**The George Washington University
Square 103 - Phase 1 Design
Garage Base Building**

**REVISED FOGGY BOTTOM CAMPUS PLAN PUD
SECOND STAGE APPROVAL**

MAY 11, 2012

A7.R

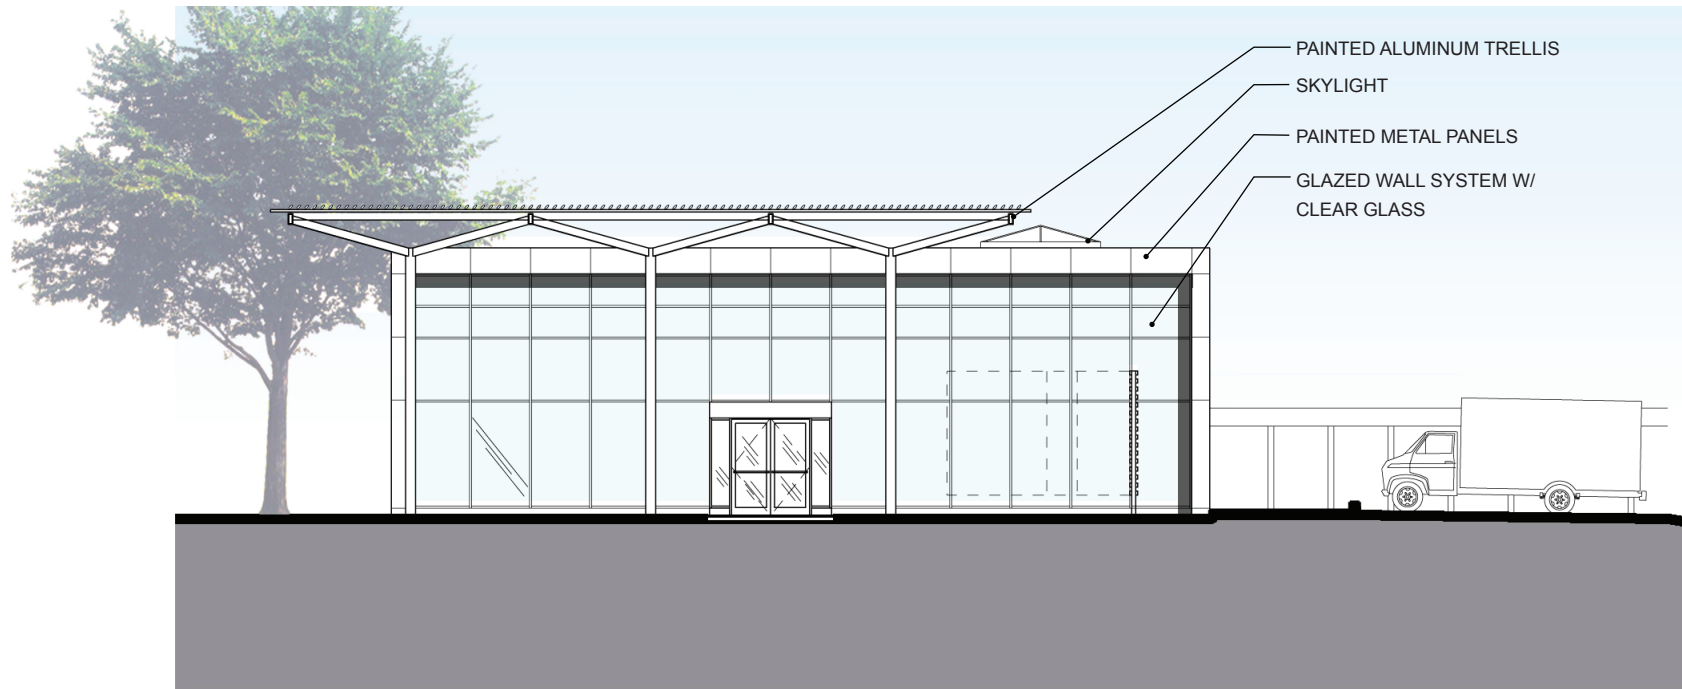
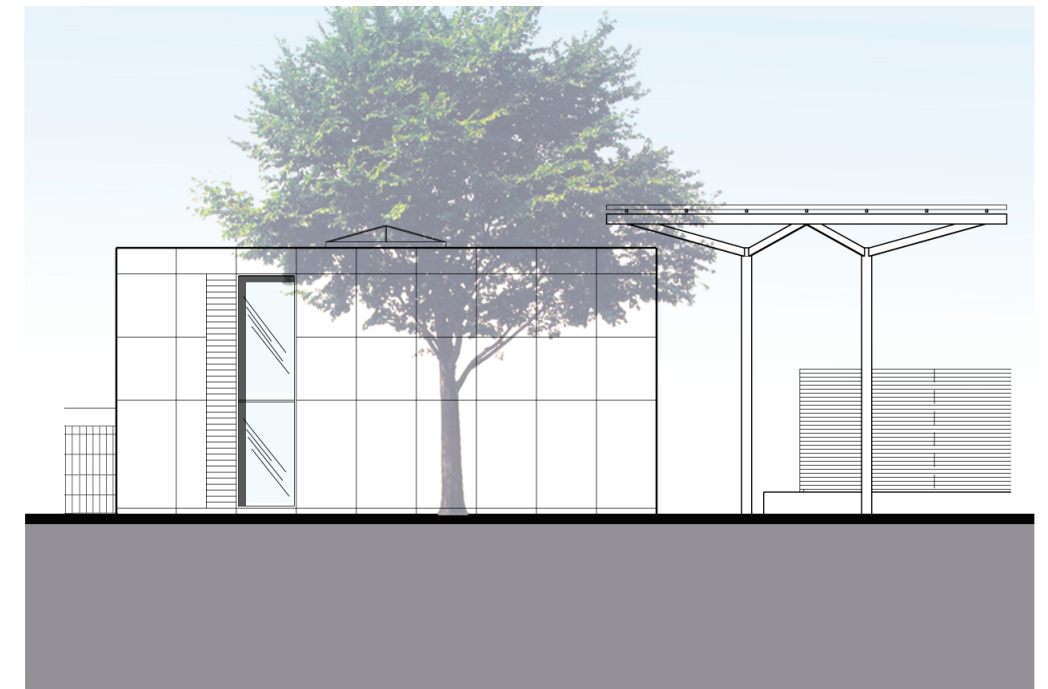
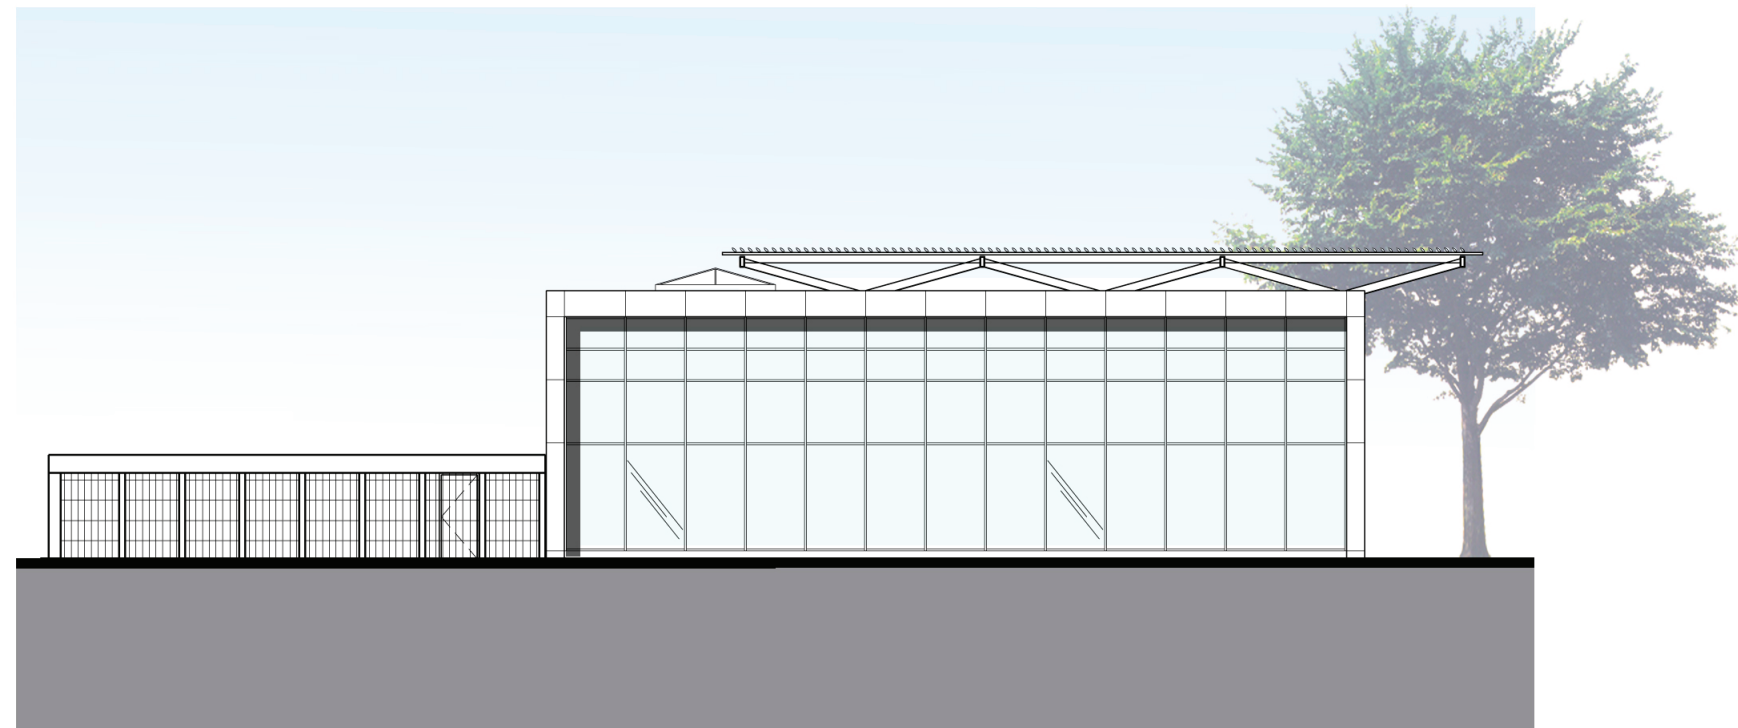
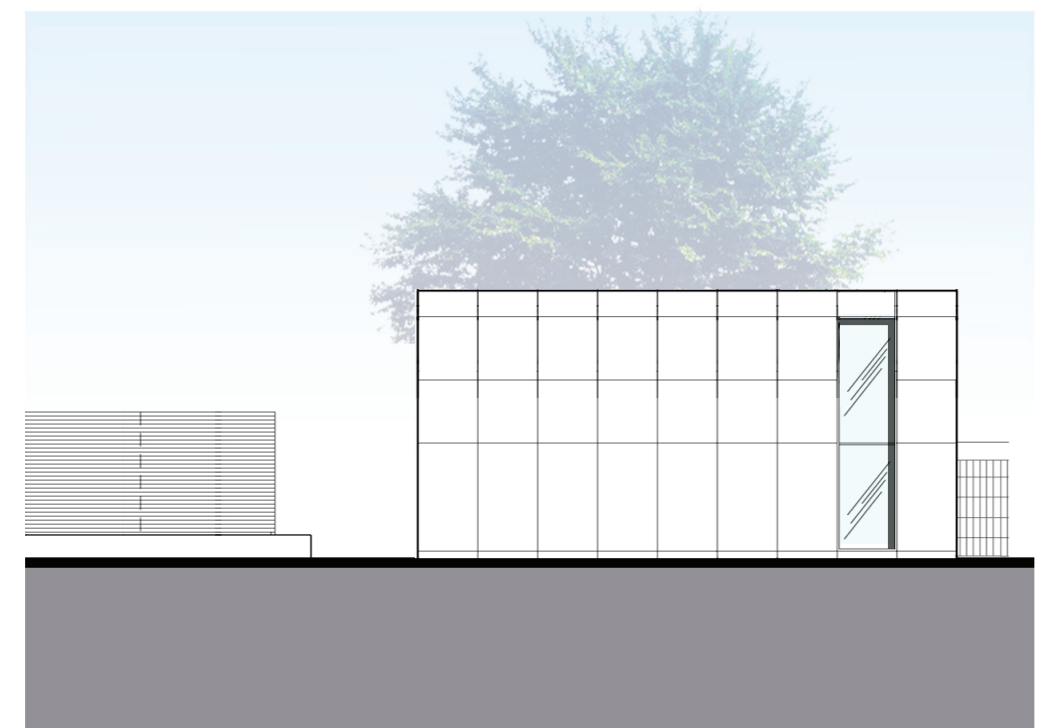
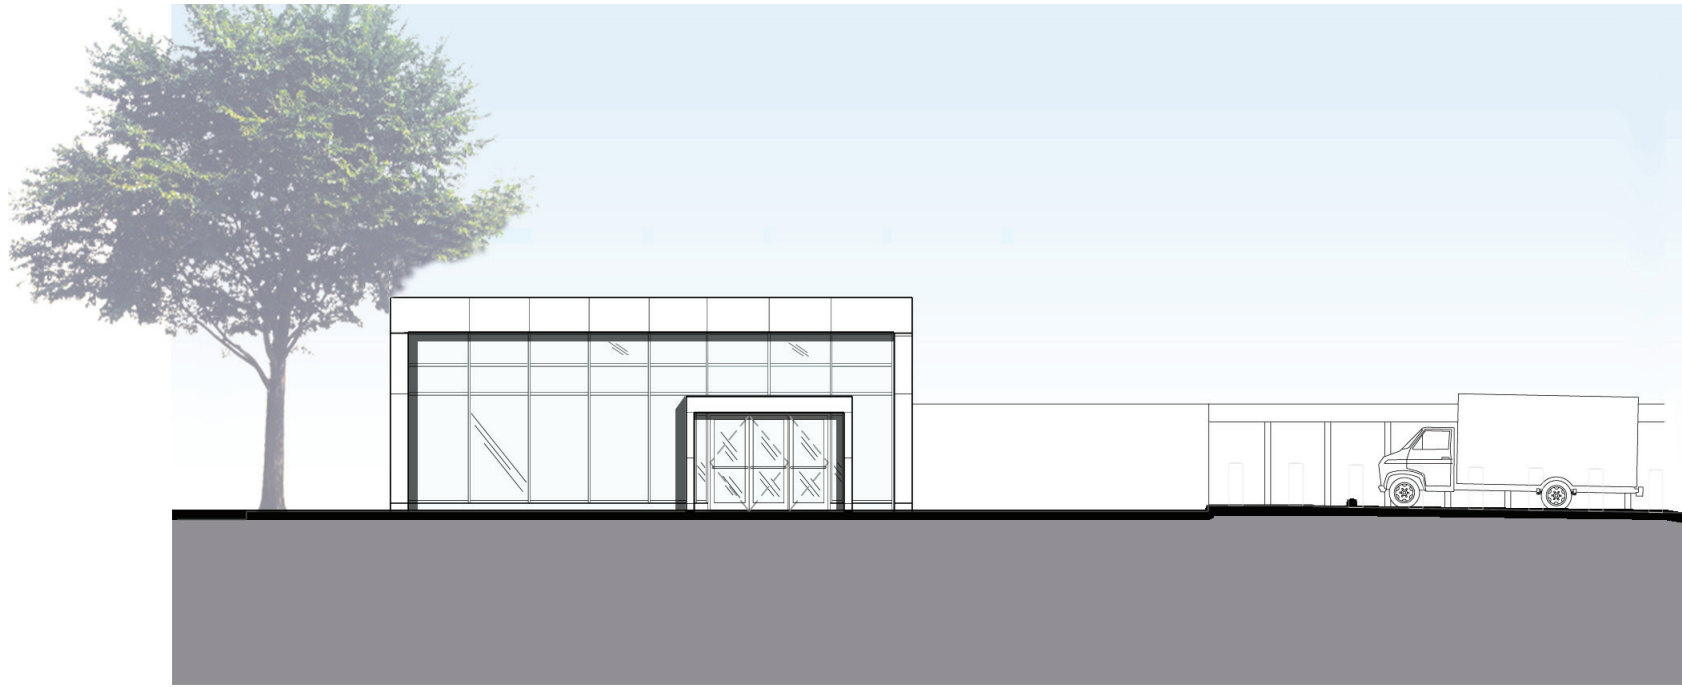
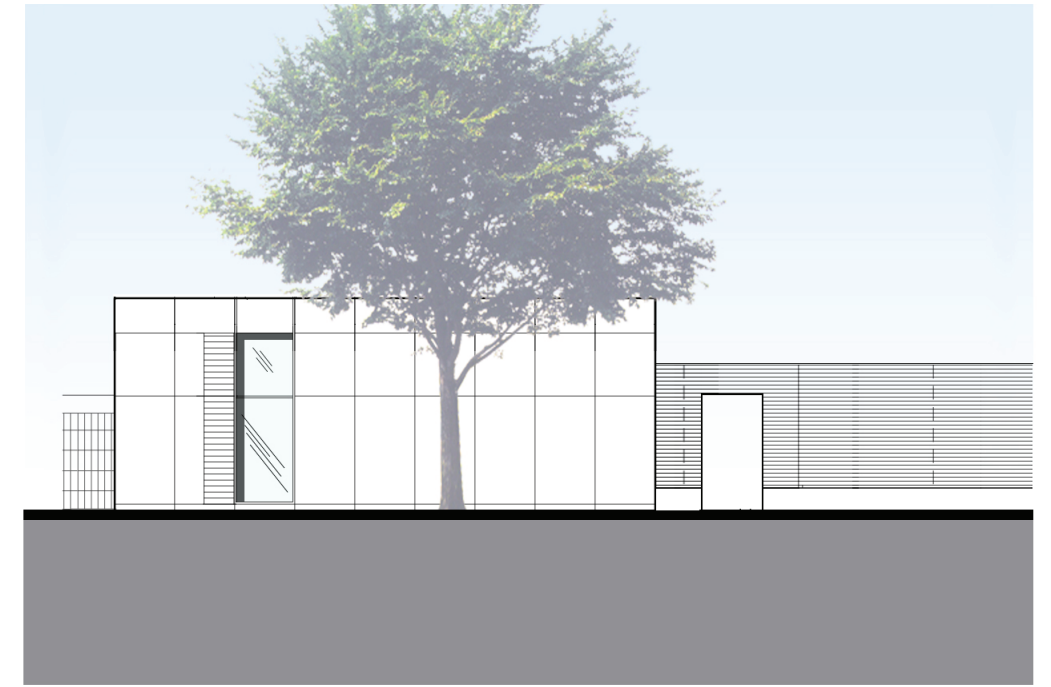
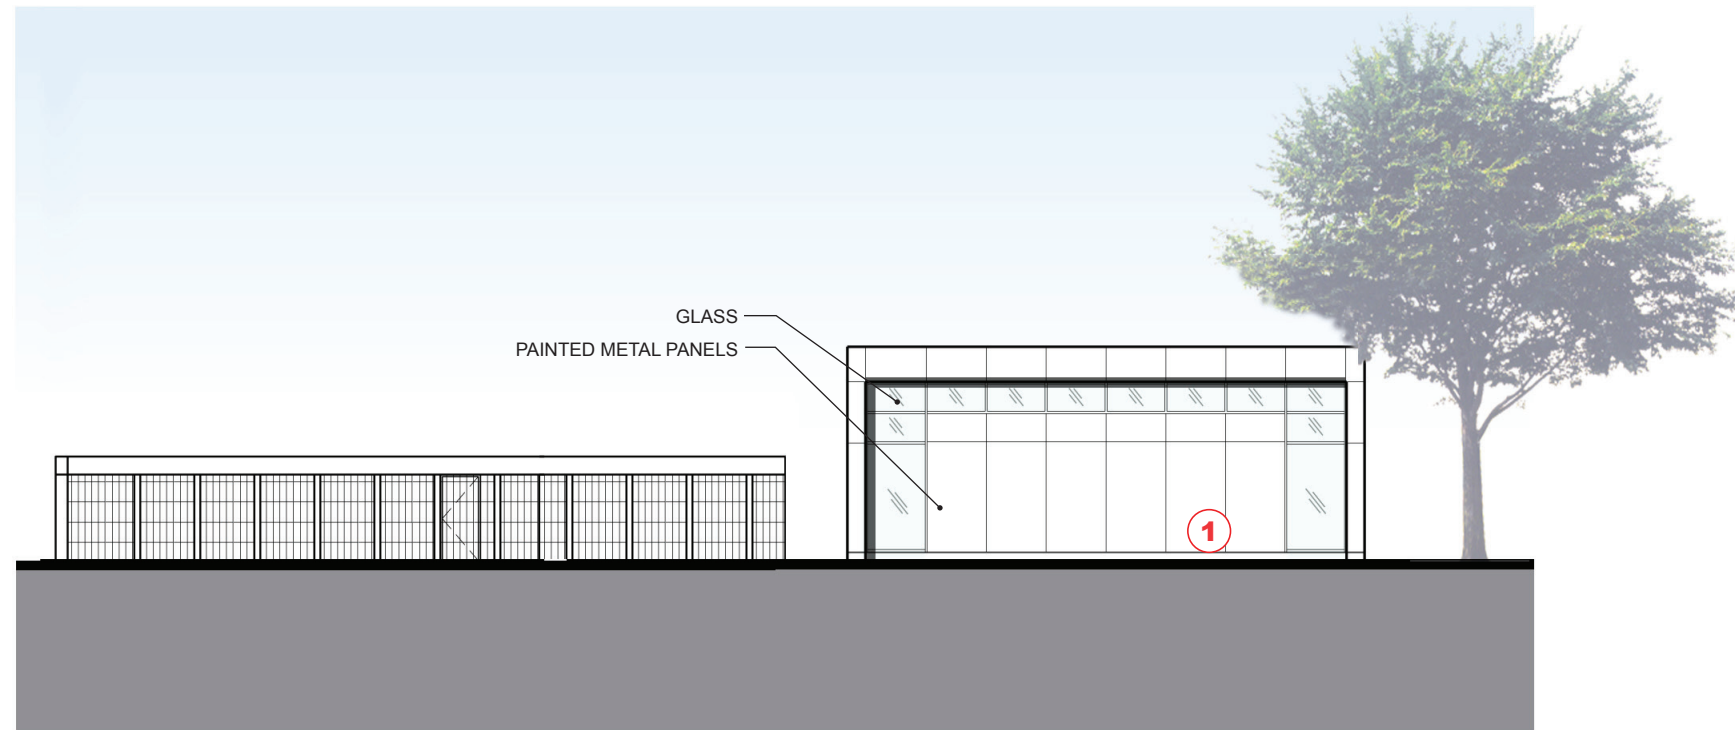
- KEYPLAN**
- 1. Increase solid areas of facade
 - 2. Simplify wood screen configuration
 - 3. Extend wood screen to the East
